Access Compliance Report

Public Rights-of-Way

(Pedestrian Signals)

Intersection ID: N/A	Main Street:	Cross Street: N/A	Location: N/A
ADA ID: F5027043FB12	Signal Type: One Push Button-APS	Overall Compliance: No	Severity Score: BTN 1: N/A BTN 2: N/A No BTN: N/A
Codes/Mitigation Info/Possible Solution		Field Measurements/Component Compliance

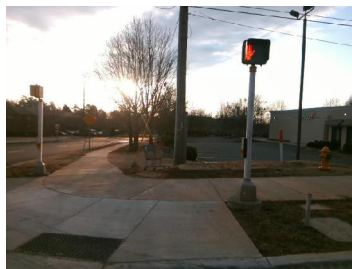
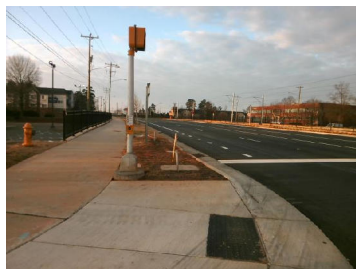
Possible Solutions: Remove & Replace
Replace APS Button With New APS Button.
Remove and Replace Clear Space.

PROW/ADA: R404.2, R404.3, R404.7.2,
R209.1, MUTCD 4e.10
